JDCL Reid Road Reservoir Quarry Woodland Edges Information

November 8, 2019 Revised June 18, 2020 Our File 9633'L'

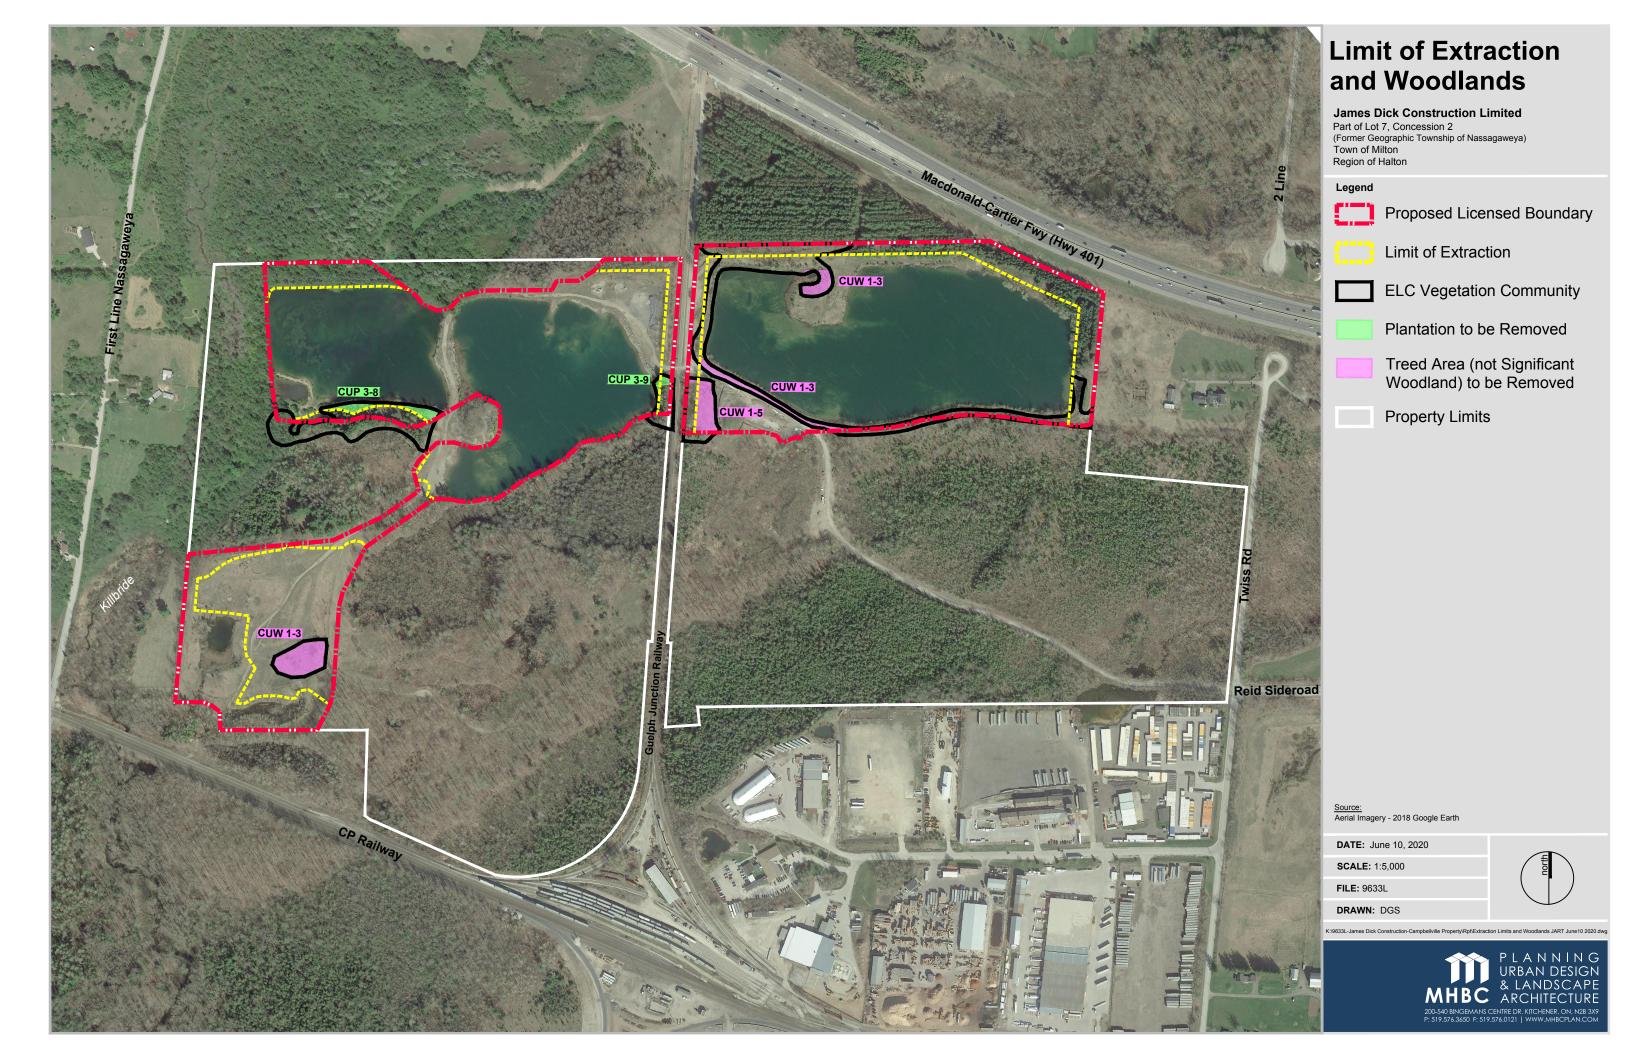
The following memo is intended to address comments #51 and 84 in the JART comment tables received on May 22, 2020. Based on changes made to the site plan, including the reconfiguration of the Buffer Pond in Phase 4 and the addition of the blasting limit shoreline setback, we have revised the woodland edges information originally presented to JART in November 2019. In addition, we have accounted for a very minimal increase in the proposed tree removal in the location of the Conveyor Tunnel.

The woodland edges are areas where the regulatory setback shown on the original site plan overlapped with the boundaries of ELC mapped treed areas. Where these treed areas are adjacent to shorelines that are not being disturbed the actual disturbance area is less than what may have been presumed because of sloping requirements so that the limit of actual extraction (blasting limit) is setback from the shoreline in the lake.

Through these site plan changes/clarifications, an additional 1.19ha of treed area will remain undisturbed. We have updated Table 1 below and compared the original calculated amount of proposed tree removal (November 2019) to the updated calculated amount of proposed tree removal (June 2019). The treed areas proposed to be removed are shown in the attached Figure. For further policy interpretation, please see attached email dated March 19, 2020.

than 60% canopy cover.	
CUW1-5	5	0.18	0.18	Mostly ash, white birch, poplar and willow regeneration. Average diameter of 10-24cm with less than 60% tree crown cover. Areas has been significantly disturbed by railway and previous extraction activities. Soil conditions and corresponding vegetation are variable.	No measurable change
CUP3-8	2	0.16	0.13	Edge of mid-age white spruce plantation. Trees with an average diameter of 10-24cm and a height of 10-25m.	reduced due to re-
CUP3-12	3/5	0.29	0 ha	Edge of mid-age White Spruce, White Pine Plantation. Average diameter of 10-24cm and height of 10-25m.	Revised based on estimate of shoreline blasting set- back
CUP3-9	4	0.02	0.04	Edge of middle age Norway Spruce plantation. Average diameter of 25-50cm and height of 10-25m	Small area added to account for tree removal in set-back for the conveyor system
TOTAL		2.07	0.88		Decrease in 1.19ha of tree removal
